Elizabeth Drive, Cecil Park Subdivision (SSD-8859)
Request for Additional Information

I refer to Amended Environmental Impact Statement and Response to Submissions for the Elizabeth Drive, Cecil Park Subdivision (SSD-8859). Further to our meeting on 19 November 2020, the Department is seeking additional information in response to correspondence received from Jemena, Transport for NSW, Fairfield City Council, Heritage NSW, Environment, Energy and Science Group and Western Sydney Parklands Trust, as well as matters identified by the Department. Any additional requests for further information made by agencies will be forwarded to you in due course.

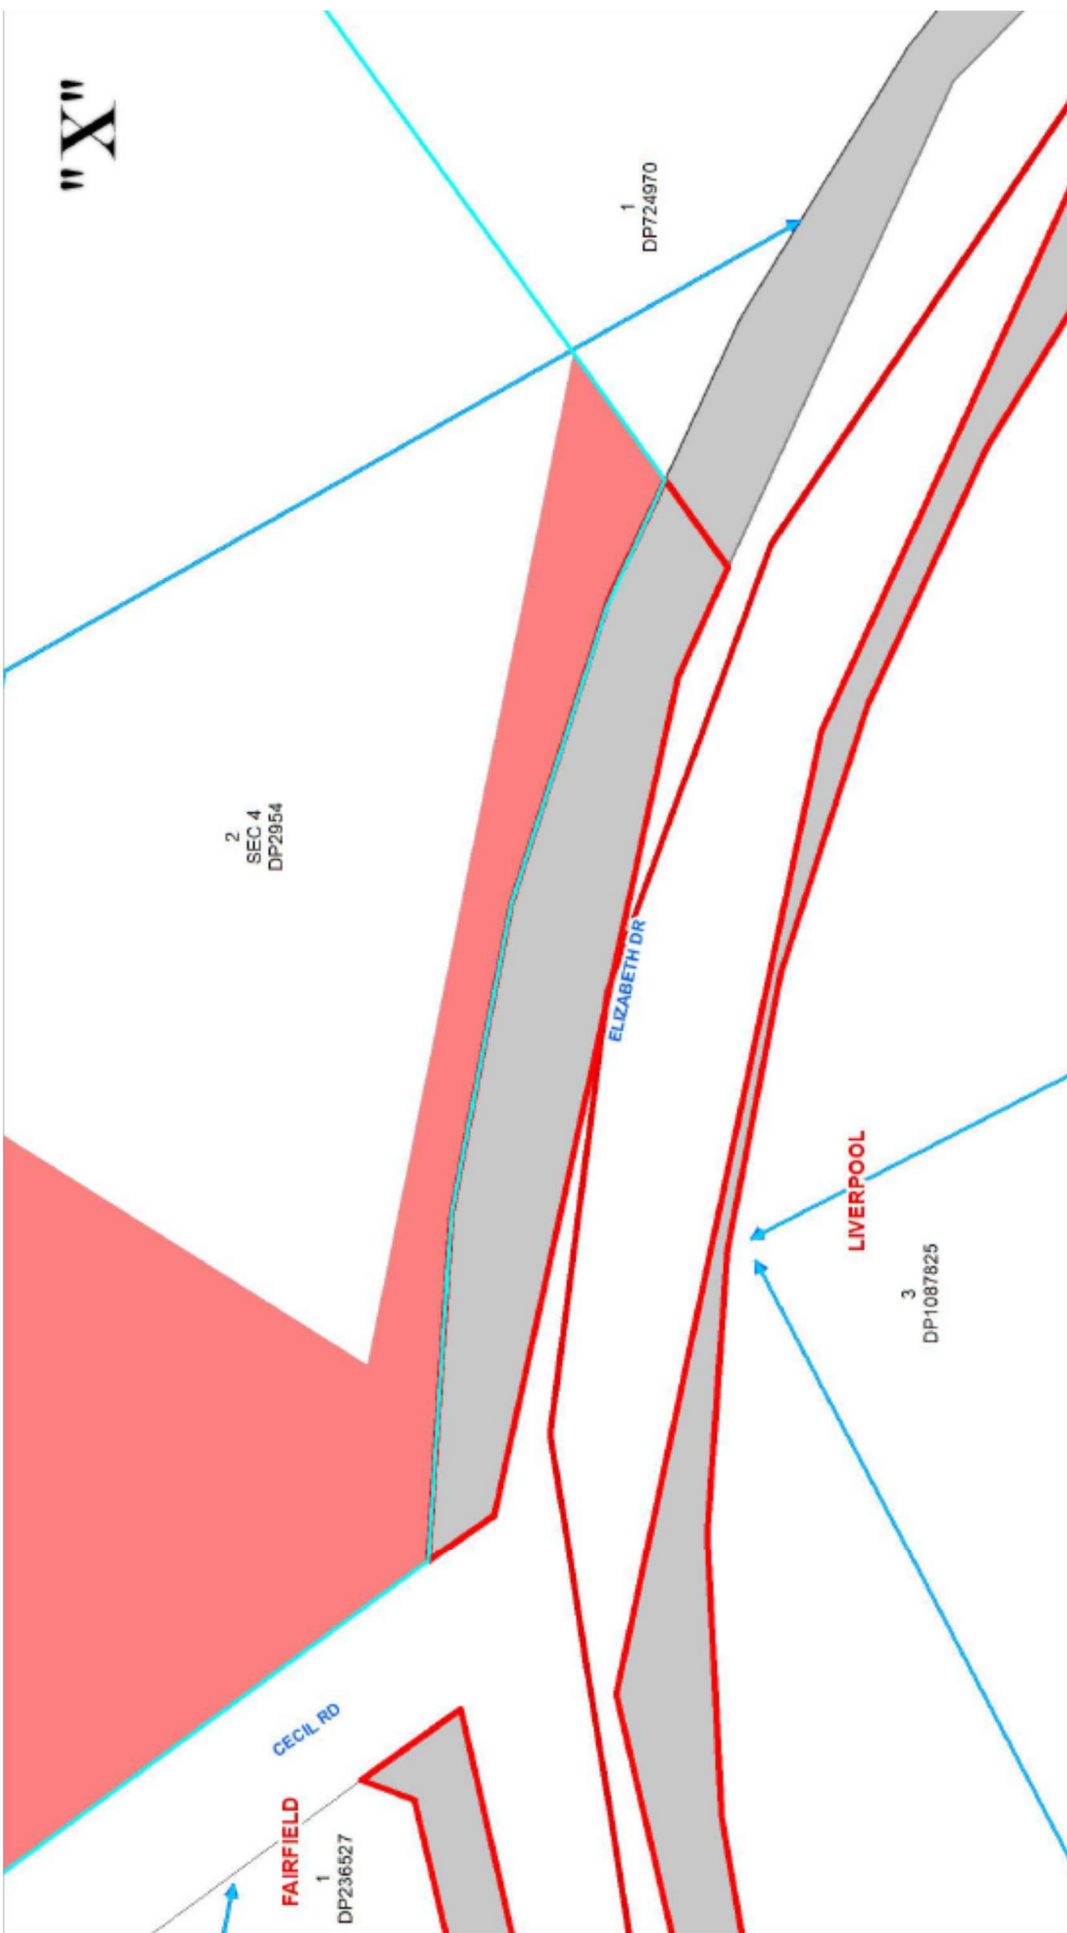
Additionally, TfNSW has previously vested a strip of land as road along the Elizabeth Road frontage of the subject property, as shown by the grey colour on the attached Aerial – “X”.

Figure 1. Gas pipelines and development plan

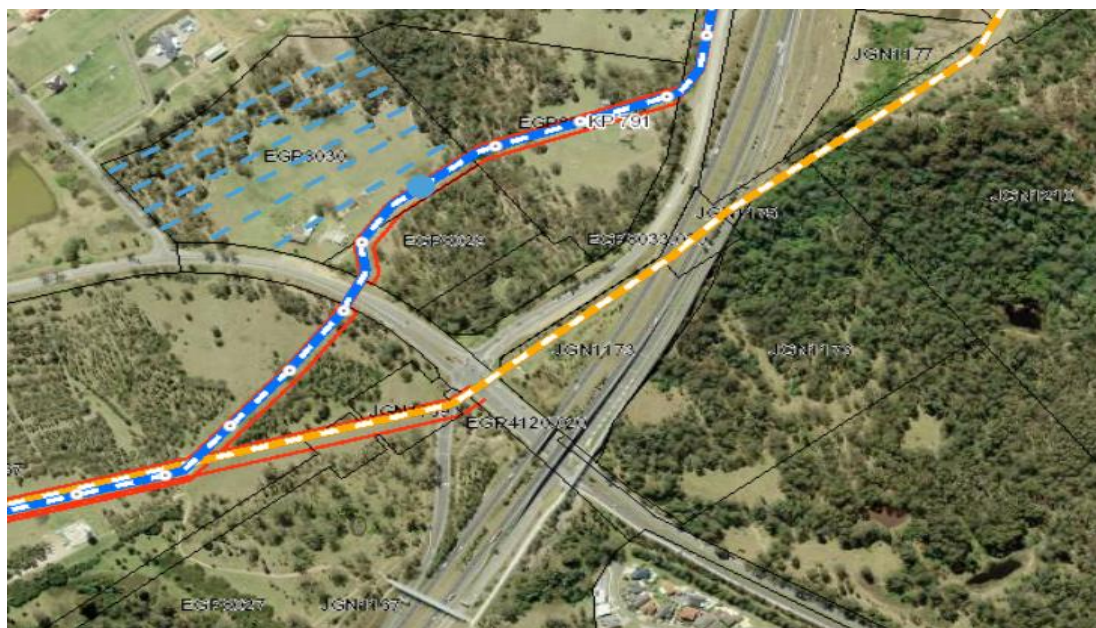
Jemena confirms that it owns and operates two high pressure gas transmission pipelines which are on or near the proposed Elizabeth Drive Business Hub .Refer Figure 1 (EGP shown in blue, Licence 1 is yellow).

The proposed development along the EGP and Licence 1 pipeline routes will have impacts on the safety and risk profile of the pipelines. In particular the inclusion of '*sensitive developments*' within the measured length of a pipeline will result in locations along the pipeline considered as HCAs. For pipeline segments located within the HCA the risk level may be unacceptable and risk mitigation measures would be required.

Jemena strongly recommends the consenting authority do not approve *Sensitive Developments* within 76m of Jemena's pipeline easement boundary.

1. The Department considers that further consideration needs to be given to Jemena's submission dated 26 March 2019 and reiterated in its submission of 12 November 2020, particularly relating to future development of the site being located within 76 metres from the boundary of its pipeline easements.

The Department suggests consideration be given to reconfiguring some of the lots so that they don't partially sit within the 76 metre setback. This includes:

- a) realigning lot 5 and lot 6 to ensure lot 5 is wholly outside of the setback
- b) realign lot 11, potentially splitting the lot into two allotments
